Addendum to the  
Supporting Information  
**Screening for Appropriate  
Assessment**

**NISA**  
*North Irish Sea Array*

# Appendix A8

## Design Refinements

Image A2.1: Refinement of WTG Layout Options for Project Option 1

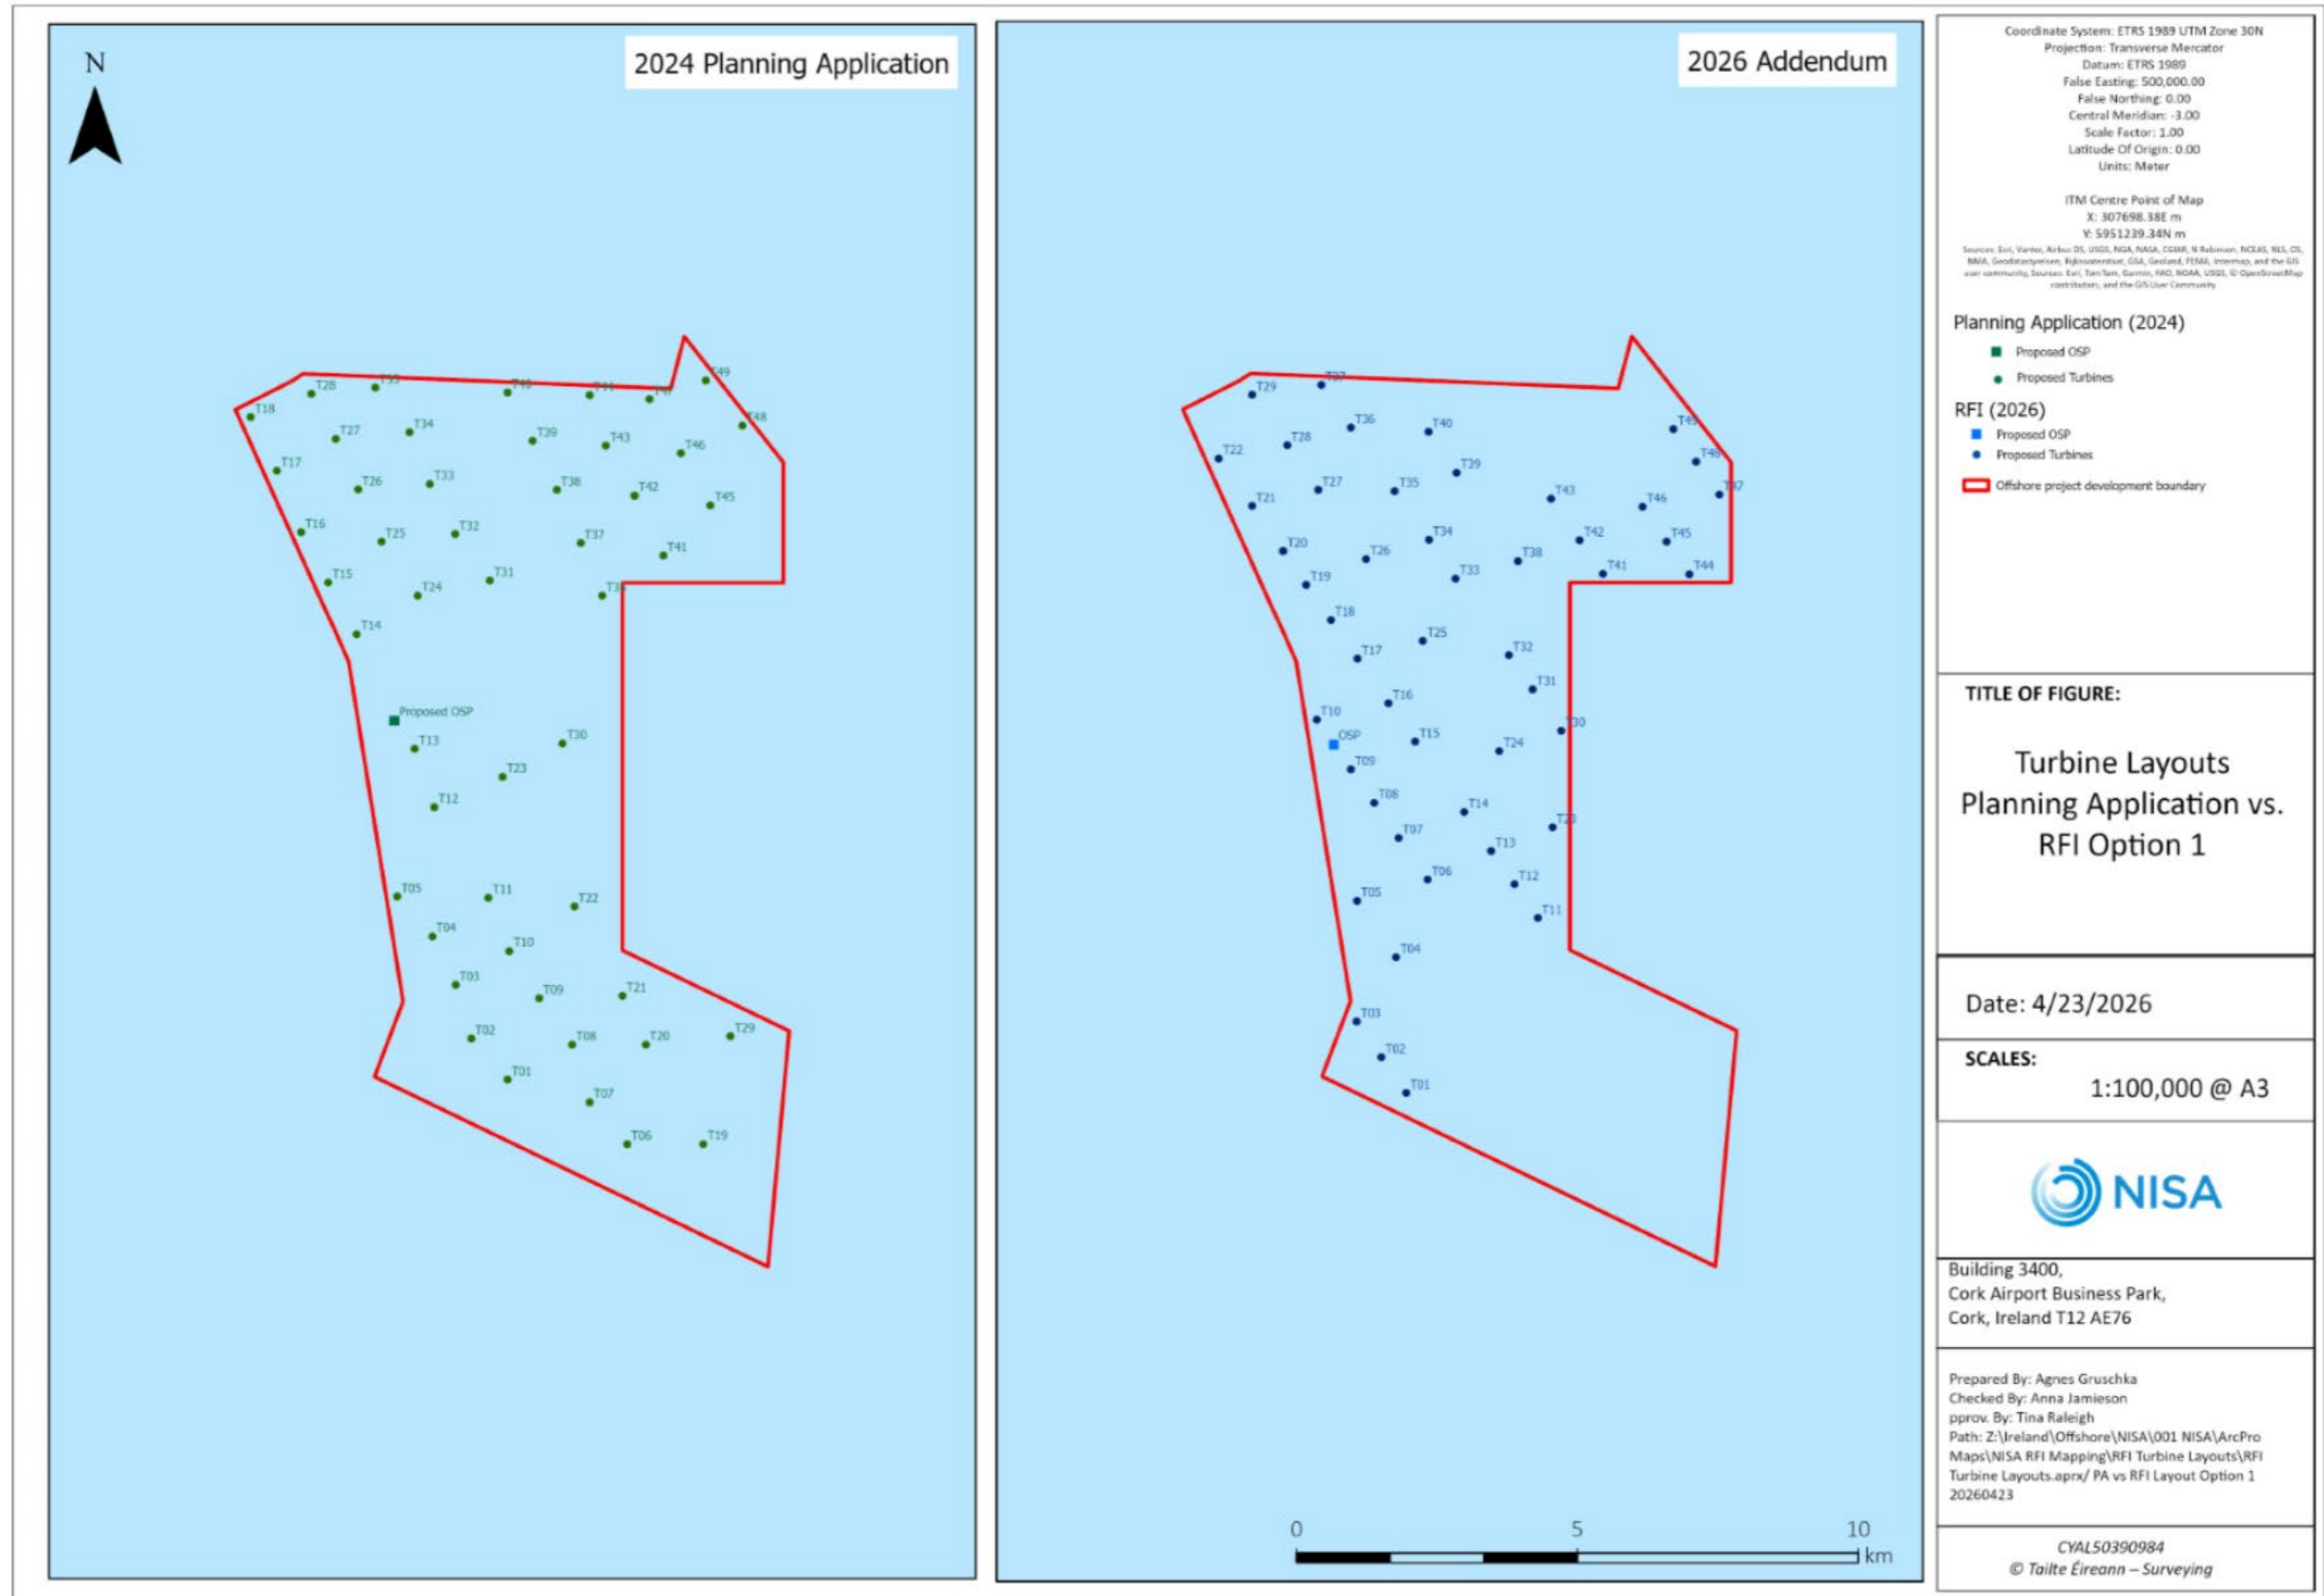
1. Refinement of WTG layouts for Project Option 1 and Project Option 2 (Images A2.1 and A2.2), to address stakeholder (IRCG and MSO) concerns around navigational safety and offshore infrastructure footprint;

RFI	Key Receptor	Specific Request within the RFI
<p>RFI 2a -IRCG, through the Department of Transport, raised concerns in relation to the layout of the proposed development with respect to search-and-rescue (SAR) access:</p> <p>The Irish Coast Guard (IRCG), through the Department of Transport, has raised concerns in relation to the layout of the proposed development with respect to search-and-rescue (SAR) access. The applicant is requested to consult with the IRCG, in addressing these concerns, and provide further information and clarification on such matters.</p>	<p>Shipping and Navigation</p>	<p>Following receipt of the RFI and subsequent stakeholder meetings, detailed consideration was given to understanding how refinements to the offshore design could further mitigate potential environmental effects from the proposed development and address key points in the RFI from the Commission.</p> <p>Since submission of the application in 2024 and additional post-submission offshore survey effort, an updated and more extensive geophysical survey was conducted in 2024 indicating an alternative foundation installation technique could be utilised which would reduce environmental impacts and address key points in the RFI.</p> <p>This extensive geophysical survey was used to create a 3D ground model of the sub-seabed in 2025 and to further inform foundation feasibility assessments, since the 2024 EIAR. The analysis of this additional survey data ascertained that monopiles could be removed as a foundation design concept for WTGs and OSP and that installation of jackets with suction buckets for the WTGs and OSP would be suitable (Image A5.3).</p> <p>Furthermore, seabed levelling is no longer required for the proposed development design. Based on the updated bathymetry from the geophysical survey campaign in 2024, it was confirmed that the seafloor across the array area is flat and uniform. Therefore, seabed levelling via dredging to create a level platform for foundation installation will not be required.</p> <p>Installation of jackets with suction buckets allowed the WTG layouts for Project Option 1 and Project Option 2 to be refined in order to address concerns raised by IRCG in relation to SAR access. This is due to the updated and more extensive geophysical survey confirming that the array area is predominantly flat, with suitable ground conditions at shallow depth. The revised understanding of the shallow geology and the increase in viable area for suction bucket jackets allows greater flexibility in siting WTGs compared to monopiles and jackets with drilled pin piles. Suction bucket foundations are a ‘shallow’ foundation type, which do not require the stronger soil or rock, typically found at greater depths</p>

<p>RFI 2b - the Marine Survey Office (MSO) disagreed with the summarisation of the risk to the safety of navigation posed to commercial shipping, fishing vessels, and recreational craft transiting in proximity to the southeastern corner and the Rockabill GAP:</p>	<p>Shipping and Navigation</p>	<p>Updated data and foundation feasibility assessments, using the updated 3D Ground model of the seabed undertaken since submission of the application, ascertained that monopiles could be removed as a foundation design concept for WTGs and the OSP and that installation of jackets with suction buckets for the WTG and OSP would be suitable.</p> <p>Installation of jackets with suction buckets allowed the WTG layouts for Project Option 1 and Project Option 2 to be refined in order to address concerns raised by MSO in relation to navigational safety. This was due to the additional geophysical survey and 3D ground model confirming that the array area is predominantly flat, with suitable ground conditions at shallow depth. This revised understanding of</p>

- 2a - IRCG raised concerns in relation to the layout of the proposed development with respect to search-and-rescue (SAR) access. This has been addressed and accepted by IRCG by updating WTG layouts for Project Option 1 and Project Option 2.

- 2b - the Marine Survey Office (MSO) disagreed with the summarisation of the risk to the safety of navigation posed to commercial shipping, fishing vessels, and recreational craft transiting in proximity to the southeastern corner and the Rockabill GAP. This has been addressed and accepted by MSO by updating the WTG layouts for Project Option 1 and Project Option 2, to increase the Rockabill GAP and to reduce the infrastructure in the south east corner.

Image A2.3: Jacket foundation on suction buckets and jacket foundation on pin piles

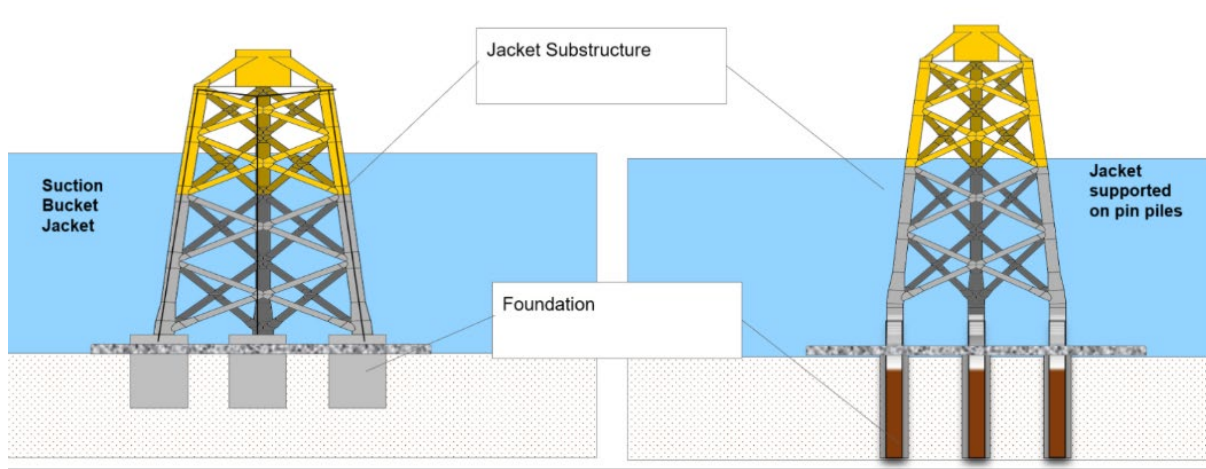
2. Removal of both driven and drilled monopile foundations and jackets with pin pile foundations as options for WTG installation from Project Option 1 and Project Option 2, and a refinement to the WTG foundation installation methodology to jackets with suction buckets (hereafter referred to as 'SBJs') for Project Option 1 and Project Option 2<sup>3</sup> to address key stakeholder (NPWS) concerns in the RFI around underwater noise. Suction buckets are a low underwater noise solution<sup>4</sup> for WTG installation and a proven technology on other wind farms<sup>5</sup> (See image A2.3 for details of suction bucket technology);

3. Removal of monopile foundations for the Offshore Substation Platform (OSP), and refinement of the OSP foundation installation to SBJs or jackets with drilled pin piles, which significantly reduces potential underwater noise effects during construction from piling activities and responds to key concerns from NPWS on this matter within the RFI; and

Information	Details/Circumstances	2024 Planning Application	2026 Addendum Design Refinements
has been made and decided.	2. Turbine Foundations (Type and Pile Dimensions)	Project Option 1: Monopiles Project Option 2: Monopiles or Jackets  Detail of the WTG foundation options and parameters are provided in Chapter 6: Offshore Project Description	Project Option 1: Jackets with suction buckets  Project Option 2: Jackets with suction buckets  Monopiles no longer proposed

3. Offshore Substation Platform (Foundation Type and Dimensions [Height above sea level, Length and Width])	Foundation Option 1: Jacket Foundation Option 2: Two Monopile Foundation Option 3: One Monopile  Detail of the OSP parameters and foundation options are provided in Chapter 6: Offshore Project Description	Foundation Option 1: Jackets with pin piles  Foundation Option 2: Jackets with suction buckets  Monopiles no longer proposed
